**STAFF REPORT**  
**COMMUNITY DEVELOPMENT DEPARTMENT**

DATE: 3/9/2021  
 TO: Mayor & City Council  
 FROM: Joseph Dodson, Associate Planner  
 208-884-5533  
 SUBJECT: FP-2021-0005  
 Sagewood West Final Plat

A Final Plat consisting of 53 detached single-family building lots and 7 common lots on 10.37 acres of land in the R-8 zoning district. *Entire Sagewood West subdivision is proposed in this final plat; there should not be any future final plats for this project.*

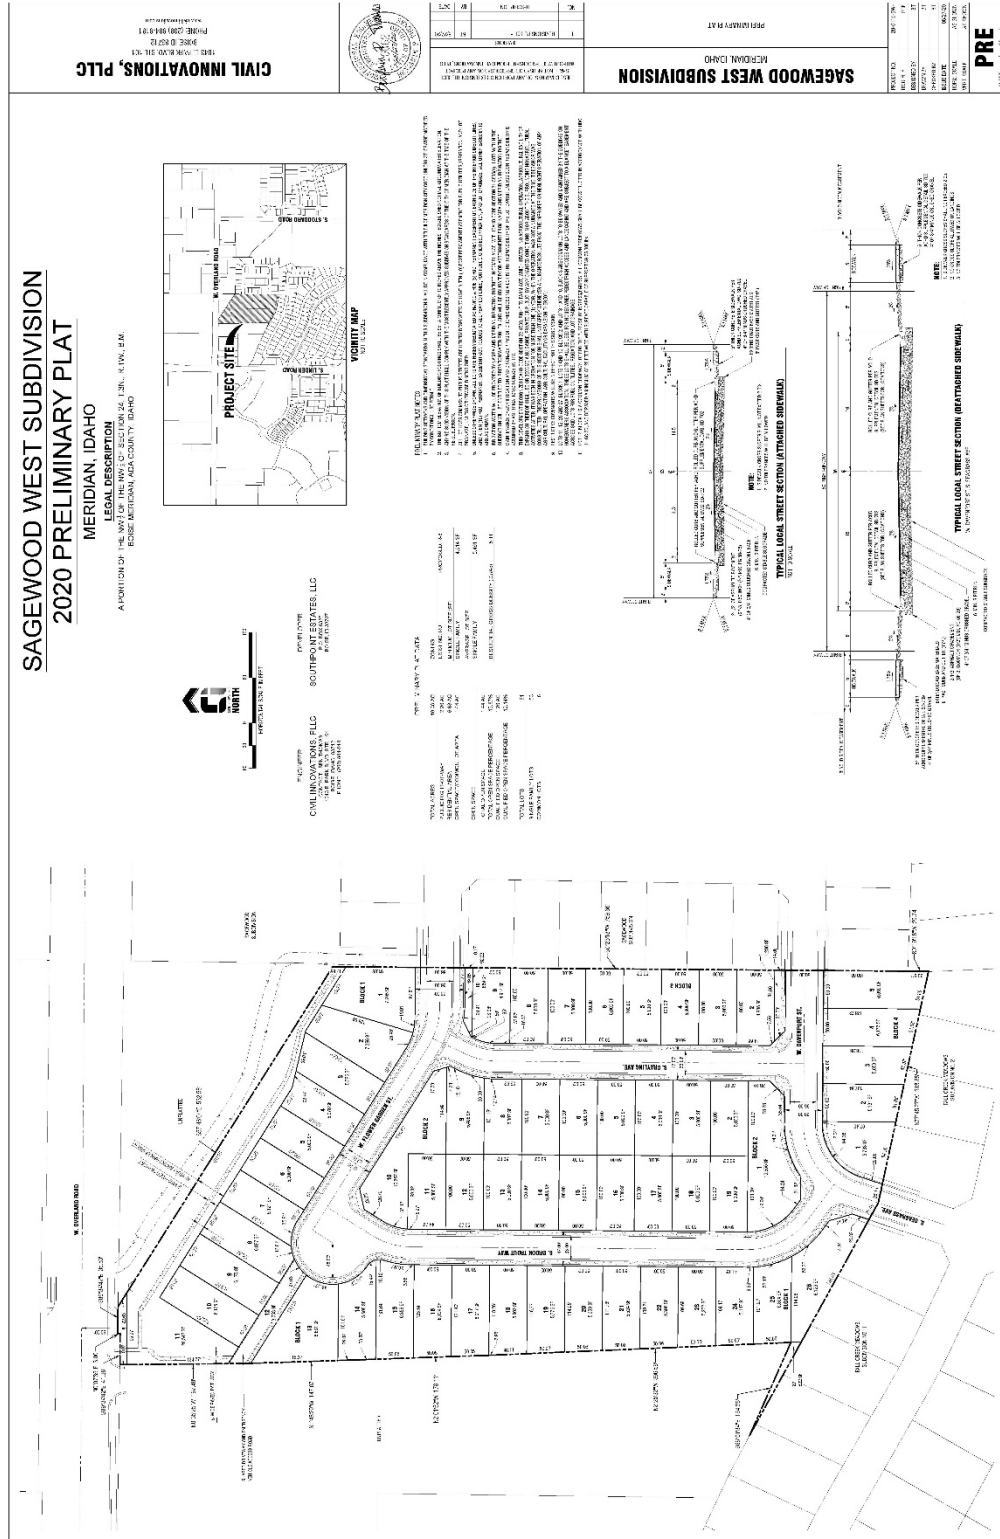
- a. Note #7: Include recorded license agreement number.
  - b. Note #12: Modify to include note that Lot 12, Block 1 is also an emergency access for the benefit of the property to the west (Parcel # S1224223275).

- c. Note #14: Include recorded agreement number.
  - d. Revise the plat to show Lot 12, Block 1 (the common lot and emergency access) as continuing west all the way to the west boundary as shown on the approved preliminary plat.

D. Common Drive Exhibit

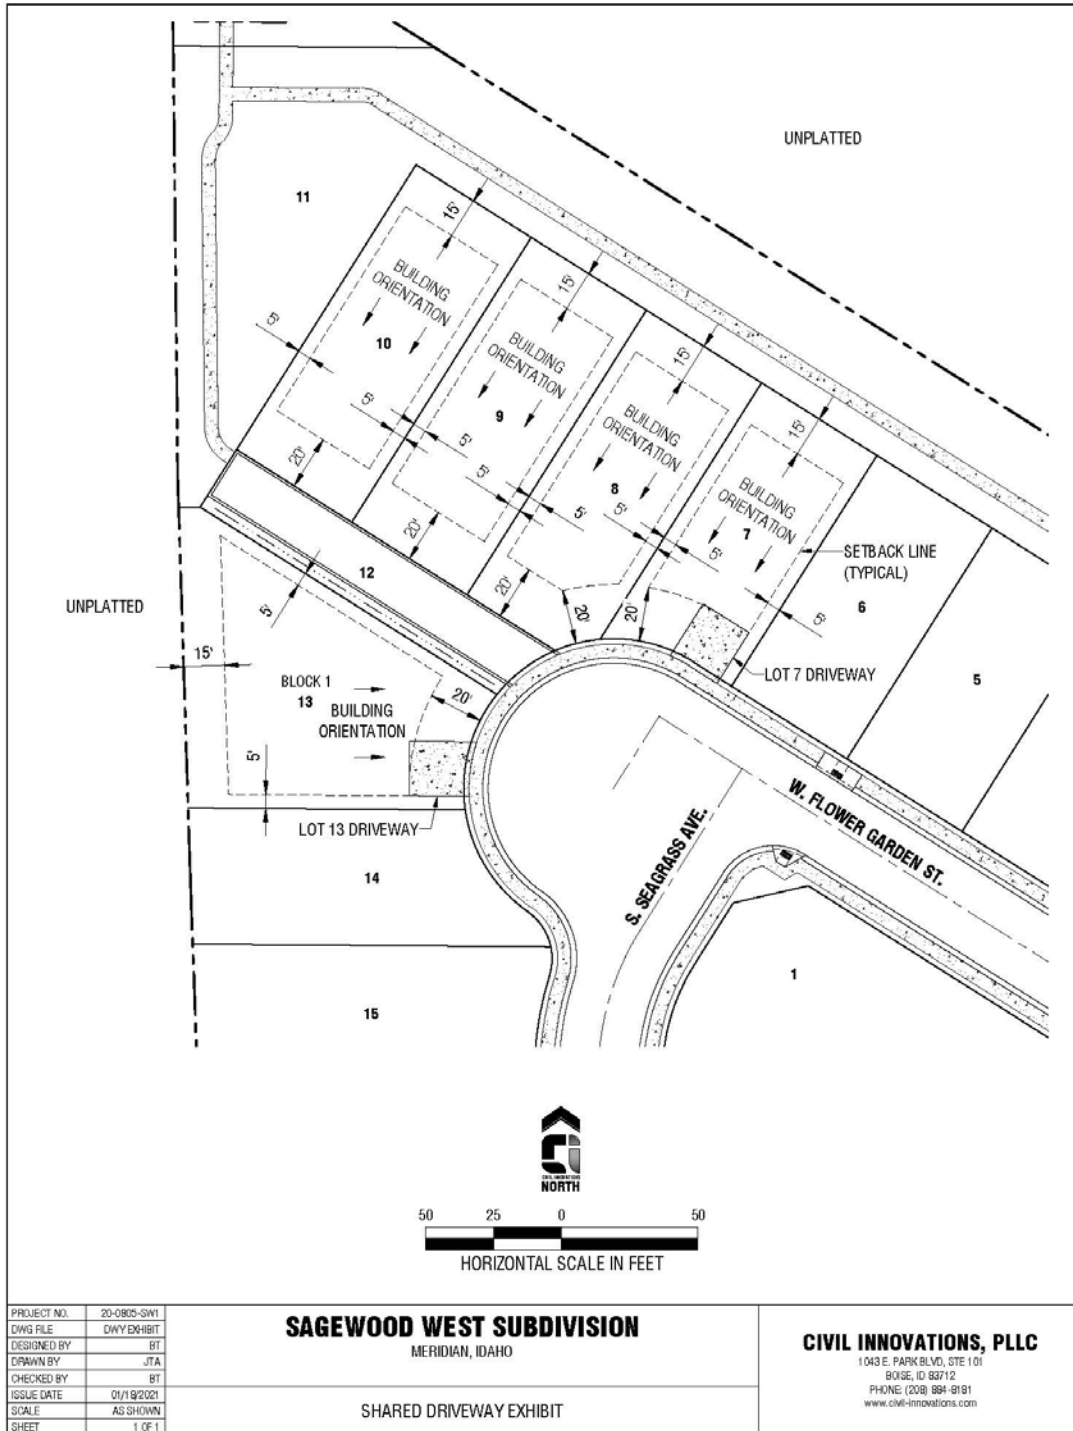
5. The landscape plan prepared by Jensen Belts Associates (Exhibit C), dated February 26, 2021, is approved as submitted:
6. Prior to signature on the final plat by the City Engineer, the Applicant shall revise the common drive exhibit (Exhibit D) to match the revisions shown on the revised landscape plan (Exhibit C).
